# Service Information Bulletins

# 1998

**GRUNDIG**

Car radio connector block

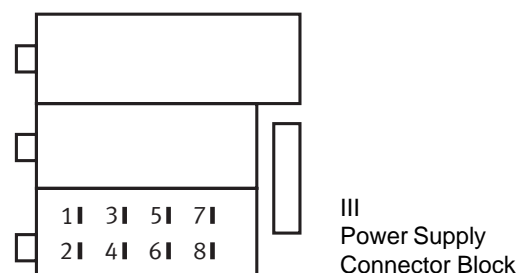
When fitting a Grundig car radio into a motor car manufactured by VW (car models Golf and Passat from year of manufacture 4/98), the following fault symptoms may appear dependent on the type of radio:

VW company have changed the pinning of the car's ISO power supply connector for the car radio. Contact 5 was previously provided for a positive voltage switched by the car radio (for antenna/booster). From 4/98 models onwards, an unswitched positive voltage may be applied to this contact.

Please ensure that no unswitched positive voltage is applied to contact 5 of the motor car otherwise remove the contact from the connector block and insulate it appropriately.

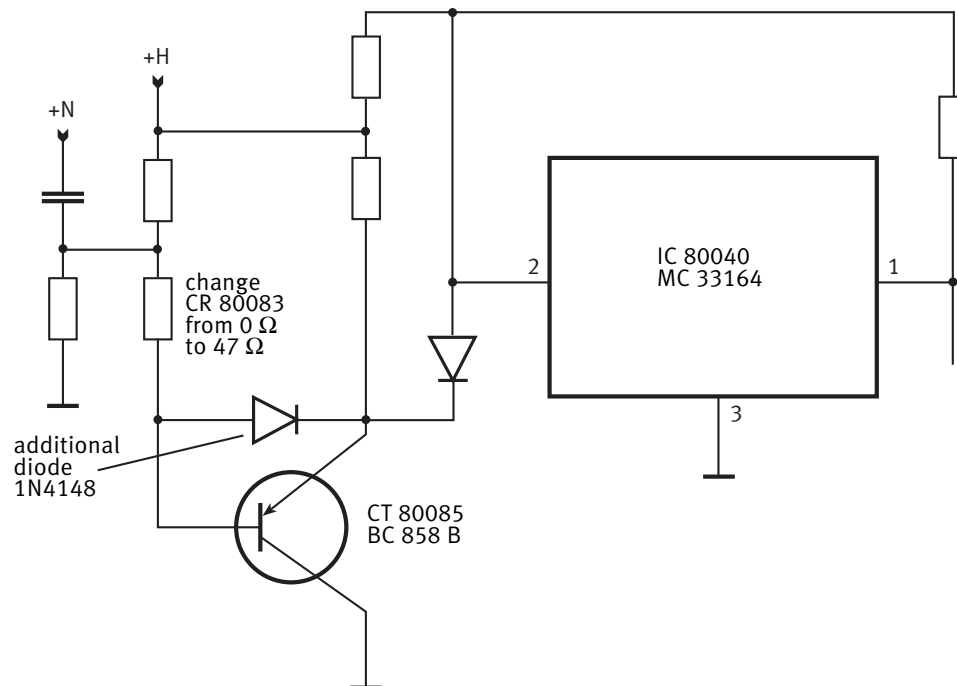
When switching on with the mains switch the television receiver goes to Standby and cannot be switched on again with the remote control handset.

Failure of transistor CT 80085 BC 858B (position X=148, Y=18).

On replacement of the transistor, solder an additional diode 1N4148 from the base to the emitter (anode to base) of CT 80085 and change the resistor CR 80083 from 0 Ω to 47 Ω 5% (structural shape 0805).

The additional diode can be fitted to the solder side between the base of CT 80085 and the cathode of diode CD 80081.

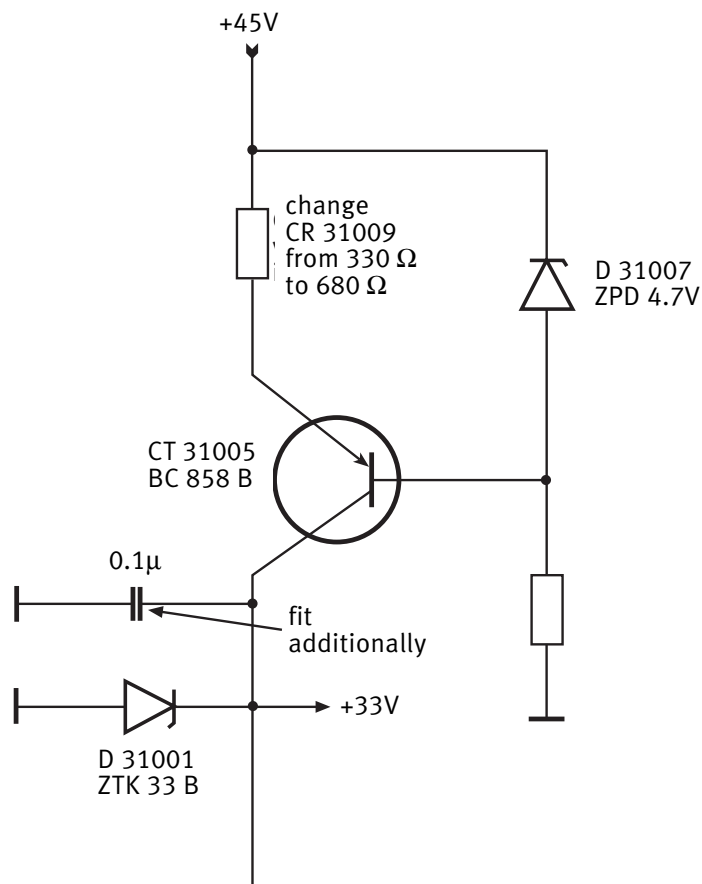
No programmes receivable.

Failure of diode D 31001 ZTK 33B caused by too high a Zener current.

On replacement of the the Z-diode ZTK 33B, change additionally the SMD resistor CR 31009 from 330 Ω to 680 Ω 5% (structural shape 0805) and solder an additional 0.1μF foil capacitor in parallel with Z-diode ZTK 33B.

When the Z-diode failed, change the resistor (position X=78, Y=10) and solder an additional capacitor.

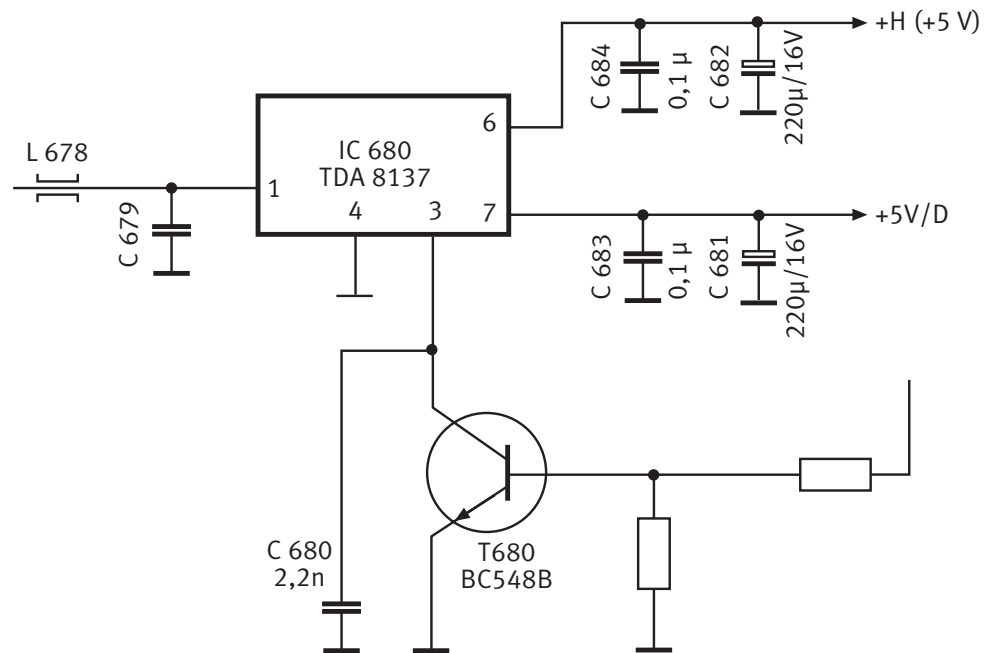
Tearing of the displayed menus and teletext pages.

Failure of the capacitors C 683 and C 684 of 0.1  $\mu$ F each.

Change the electrolytic capacitors C 681 and 682 of 220  $\mu$ F/16 V each in addition to the capacitors C 683/684.

Fig. 1

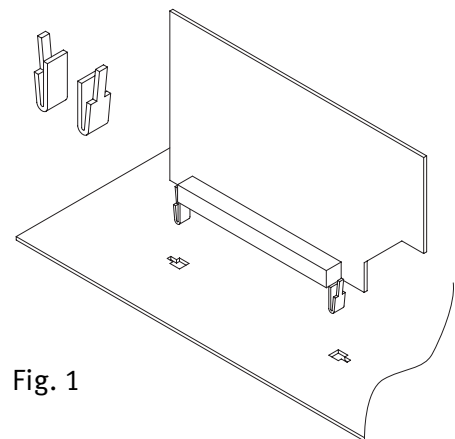
1. The traditional black socket terminal strips of the modules are additionally provided with locking lugs which, in addition to a module holder, prevent the module from slipping out. The module can be dismantled from above or below by pressing the locking lugs together.

Fig. 2

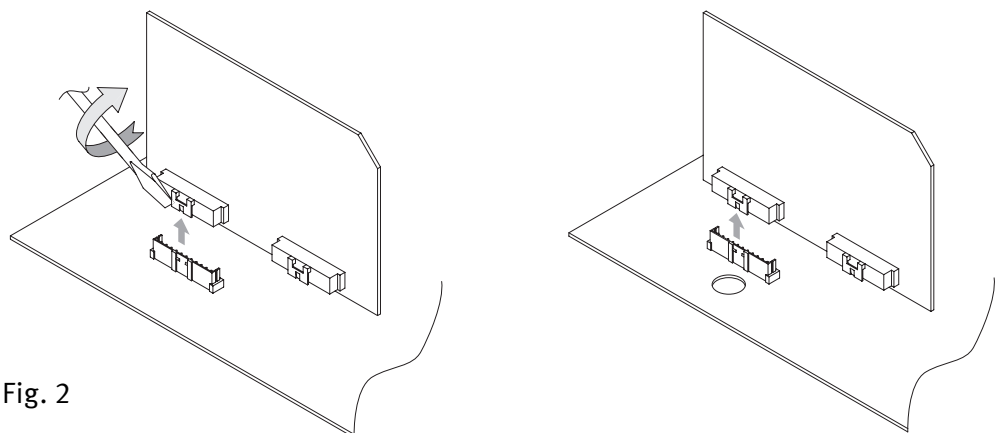
2. The modules of the colour television receivers with chassis CUC 20xx are fitted with a new plug-in system. They can be dismantled by disengaging the locking lug with a screw driver. In future, it will also be possible to release the lugs from below through additional drilled holes in the chassis.

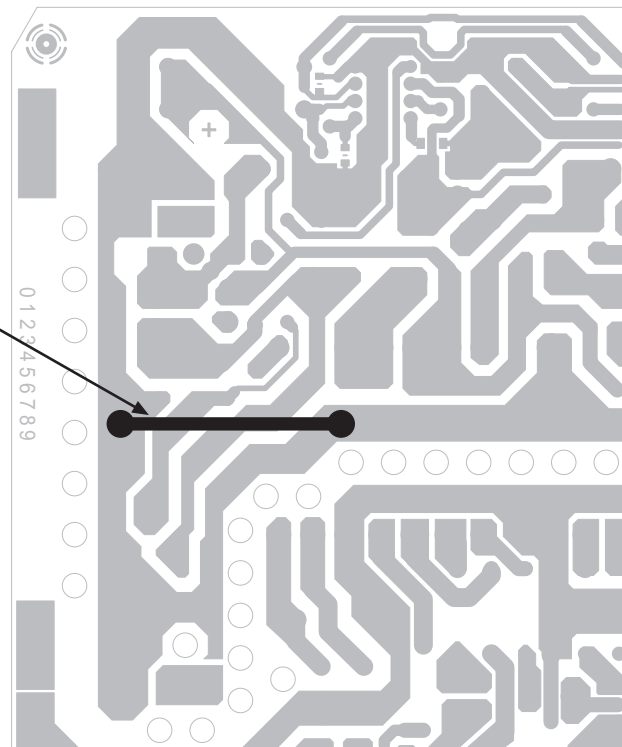
Interference in FM reception in the immediate vicinity (approx. 2m) of a switched on television receiver.

Solder an insulated wire of approx. 35mm (2.5mm<sup>2</sup>) in length on to the solder side of the mains supply section (between pos. R60007 and C60001) as shown below. This additional wire is used to short-circuit the ground loop which has been found to be the source of interference.

Solder in a bridge between these points and fix it with a heat-set adhesive

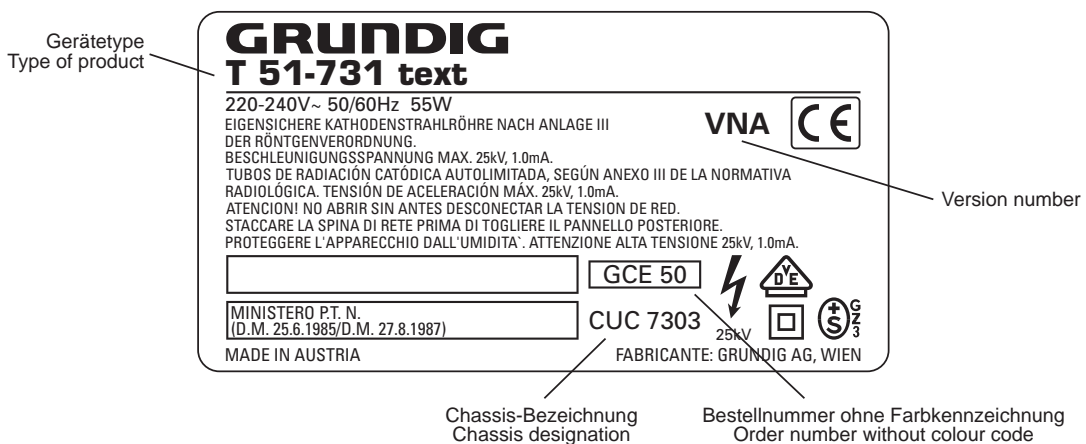
Dependent on the picture content (black/white changes) these TV sets switch occasionally to Standby.

Change the resistor CR 21234 from 220  $\Omega$  to 390  $\Omega$ .

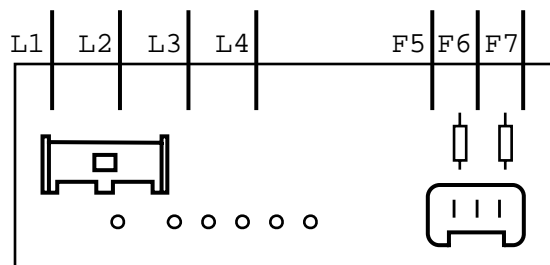
The picture tubes A 68 ESF 002X43 (without coating) and A 68 ESF 202X43 (with coating) fitted into television receivers with above mentioned chassis are no longer available. These picture tubes are not fully compatible with the replacement tubes A 68 ESF 002X143 / A 68 ESF 202X143.

The figure below shows the connections of the deflection unit for the new picture tubes A 68 ESF 002X143 part no. 8300 068 24300 and A 68 ESF 202X143 part no. 8300 068 20400.

- L1 - red yoke connecting lead (horizontal)
- L2 - black yoke connecting lead (horizontal)
- F5 - green yoke connecting lead (vertical)
- F7 - white yoke connecting lead (vertical)

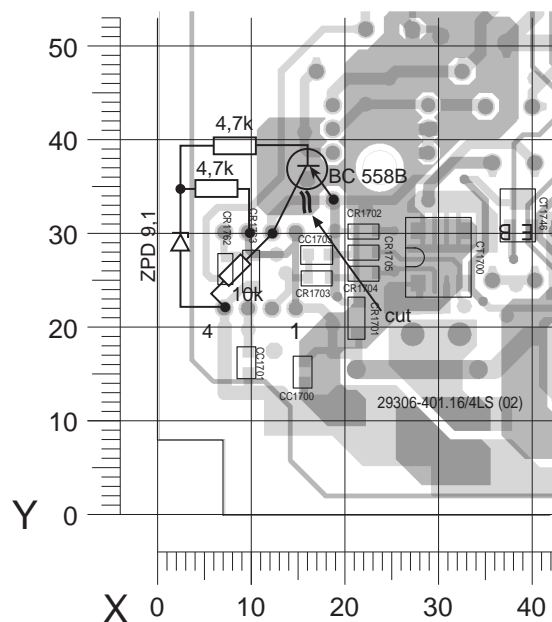
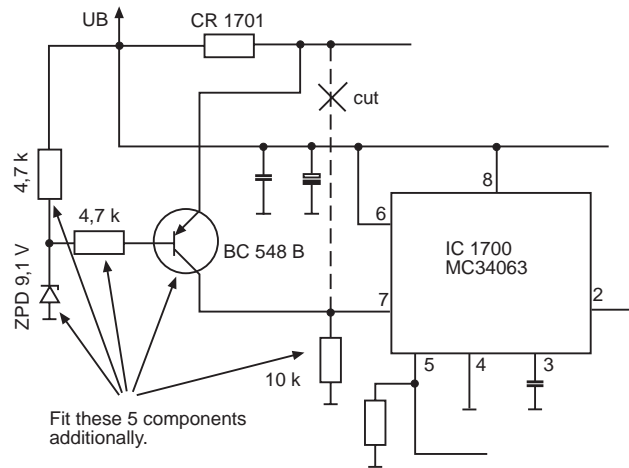
No operation.

Failure of the transistor CT 1700 Si 9955 caused by a voltage supply (battery operation) below 9V.

- Change the capacitor C 1736 from 270pF to 100pF/1kV.
- By fitting an additional transistor stage (protective circuit), the STR 100 DX switches off if the supply falls below 9V.

When CT 1700 failed, fit the following additional components (see diagram):

Extract from the circuit diagram in Service Manual  
72010-527.35, page 4-47

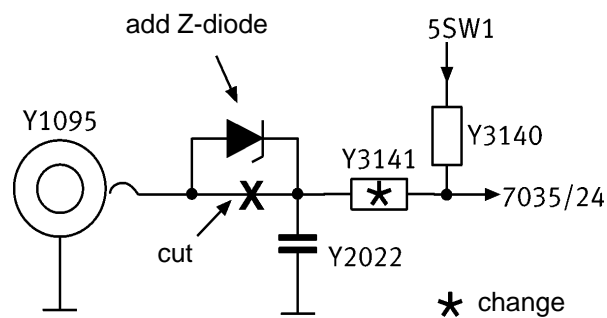
When connecting one of the above mentioned video recorders with a satellite receiver using the Sat Control Cable and the video recorder is in „Low Power Standby“ mode, the following symptom appears:

The IR receiver of the satellite receiver is blocked by pulses on the Sat Control Cable.

Change Y 3141 from 4.7k $\Omega$  to 470 $\Omega$ .

Cut the circuit path (inner conductor) between the Cinch socket Y 1095 and CR-Y 3141.

Add a 3.3V Z-diode (e.g. BZX 84 C 3V3), anode to Cinch socket.
